HISTORIC AND DESIGN REVIEW COMMISSION

December 20, 2017

HDRC CASE NO: 2017-660
ADDRESS: 231 E Houston
LEGAL DESCRIPTION: NCB 407 BLK 17 LOT E 93.51 FT OF 19 COURT BUILDING SUBD
ZONING: D, HS
CITY COUNCIL DIST.: 1
LANDMARK: George Building
APPLICANT: Peter French/Gray Street
OWNER: Gray Street Houston-219 E Houston Street LLC
TYPE OF WORK: Removal of glass storefront
APPLICATION RECEIVED: December 6, 2017
60-DAY REVIEW: February 4, 2018
REQUEST:

The applicant is requesting a Certificate of Appropriateness for approval to remove the glass storefront from 231 E Houston to create a covered area consistent with that of 229 E Houston.

FLOOR PLAN_1ST FLOOR
FLOOR

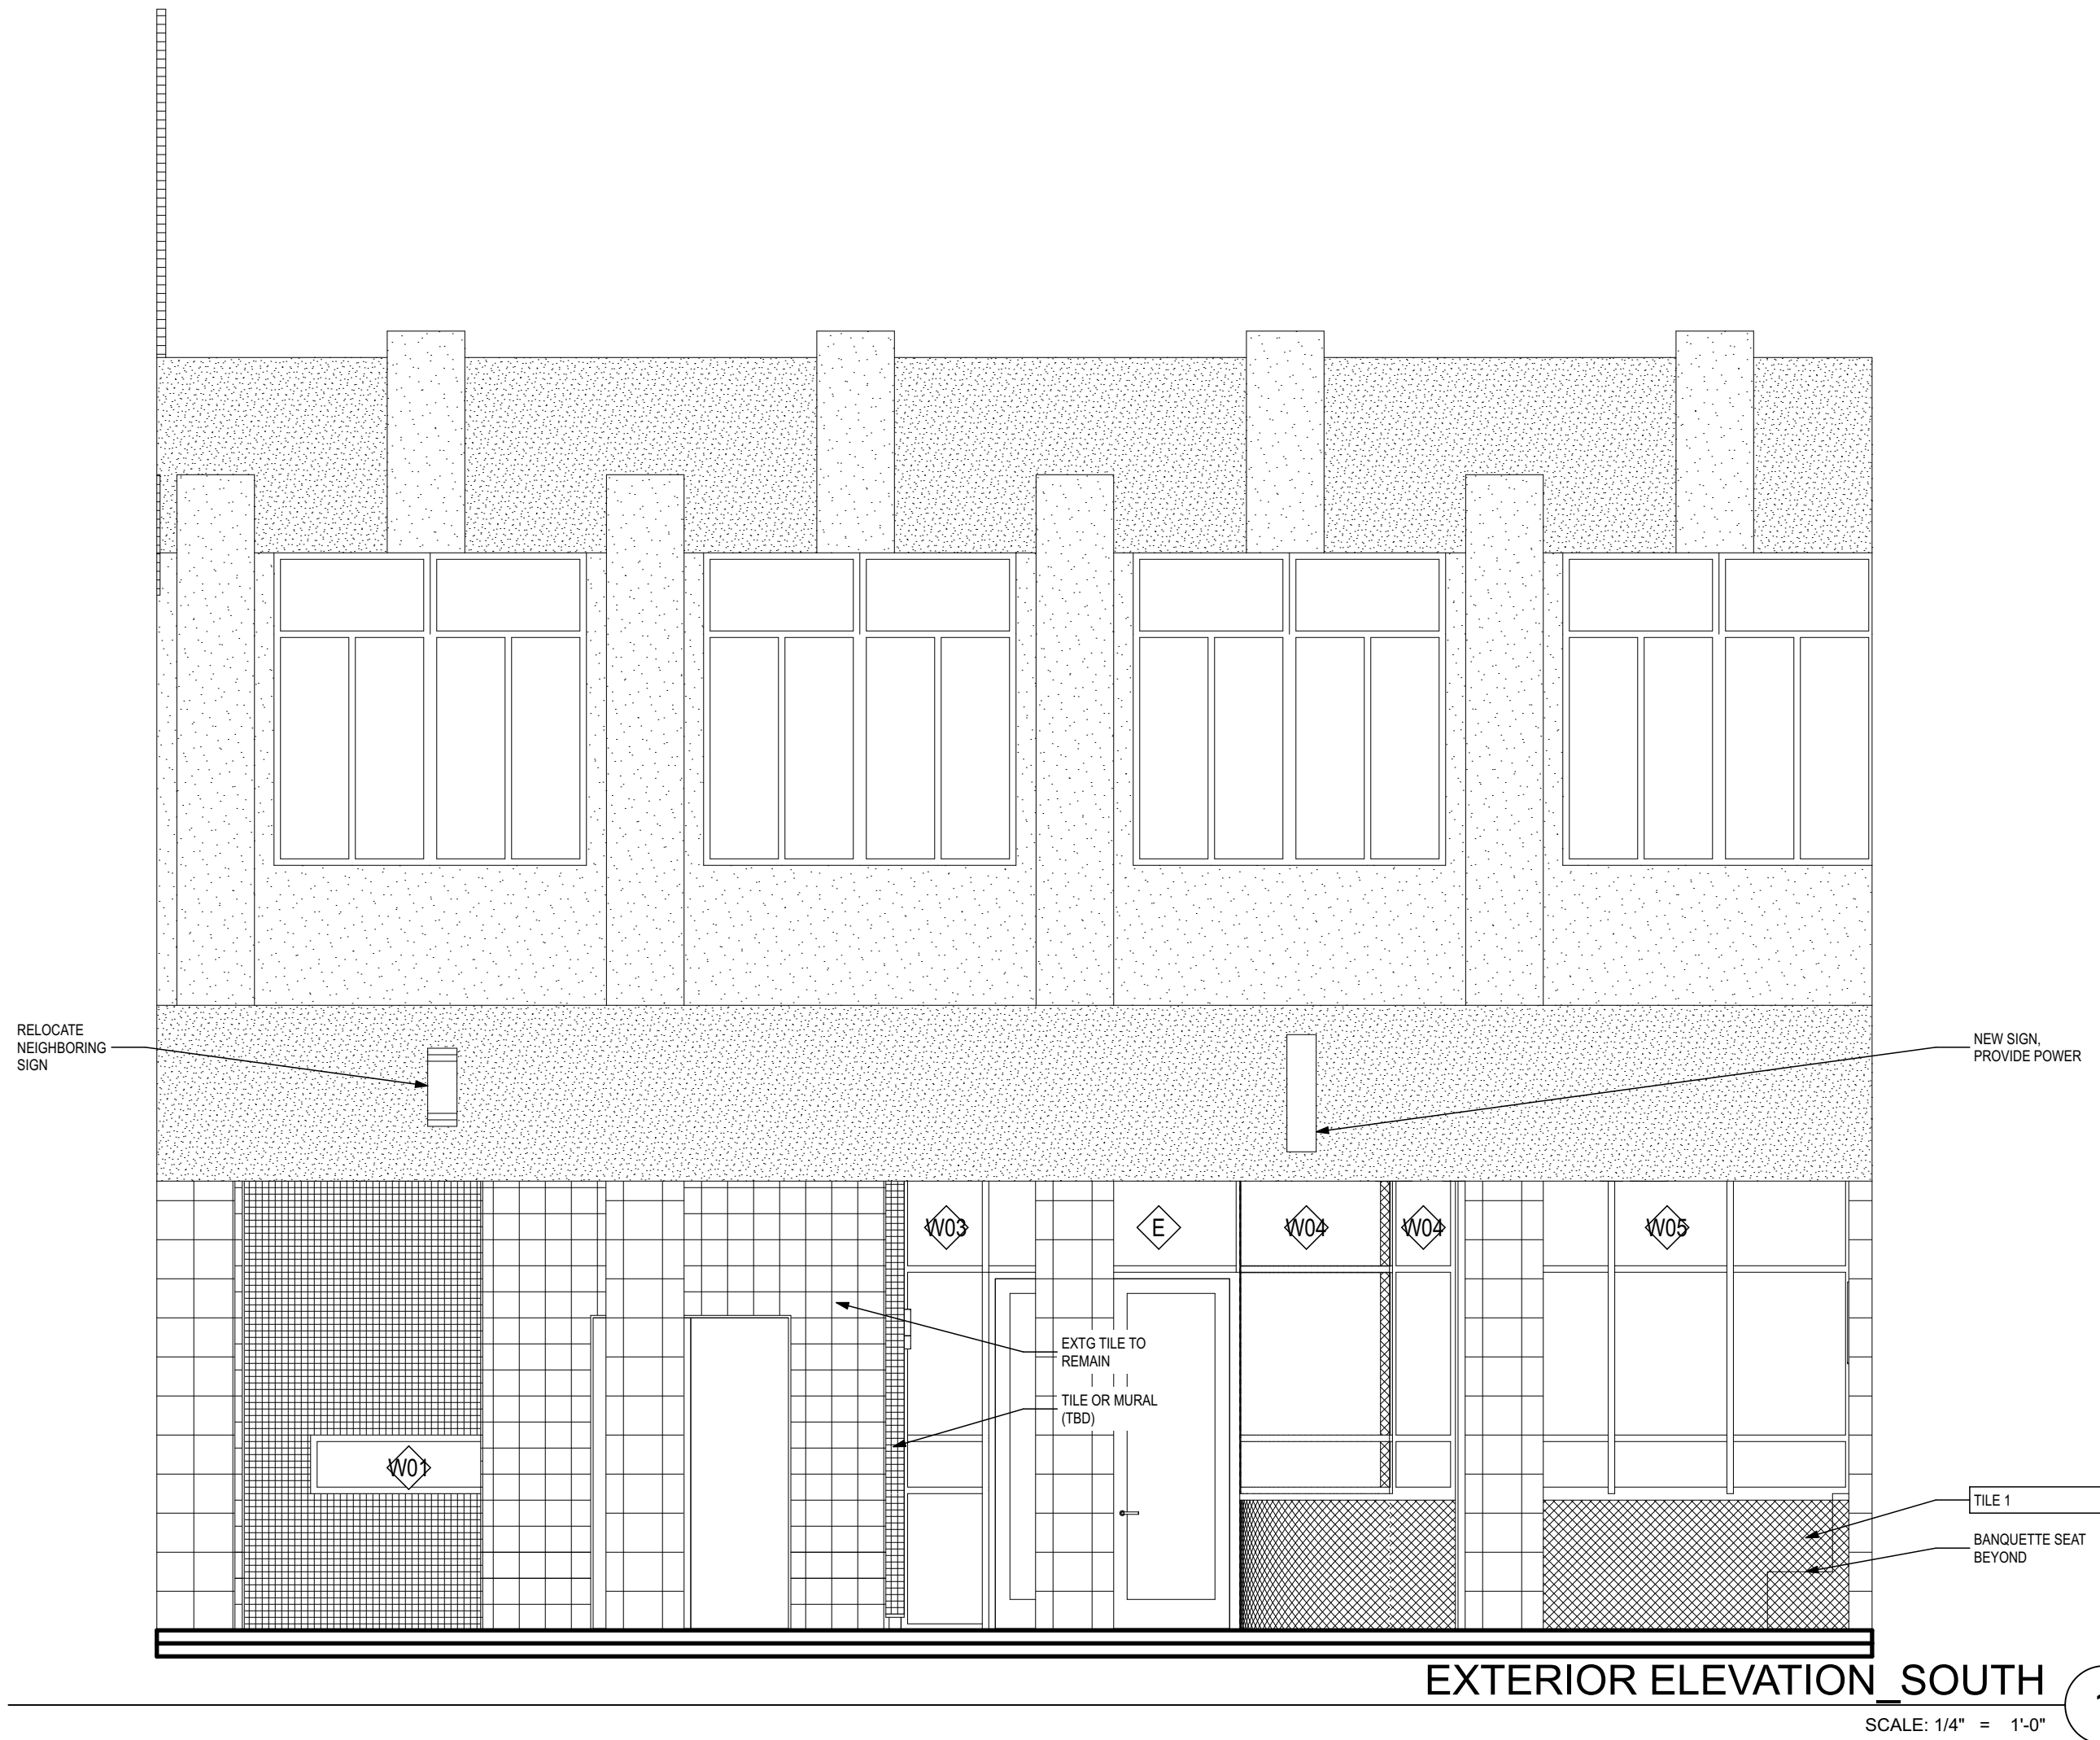
- a. The applicant is requesting a Certificate of Appropriateness for approval to remove the glass storefront from 231 E Houston to create a covered area consistent with that of 229 E Houston. The Guidelines for Exterior Maintenance and Alterations 10.A.i. notes that character defining features of historic facades should be retained. Additionally, the Guidelines for Exterior Maintenance and Alterations 10.B.ii. notes that some non-original façade elements may have gained historic significance and should be retained. Staff finds the existing storefront and façade materials to not be original to the structure and their removal to be appropriate. Final material details and site furnishings are to be submitted to staff for review and approval.

Staff recommends approval based on finding a.
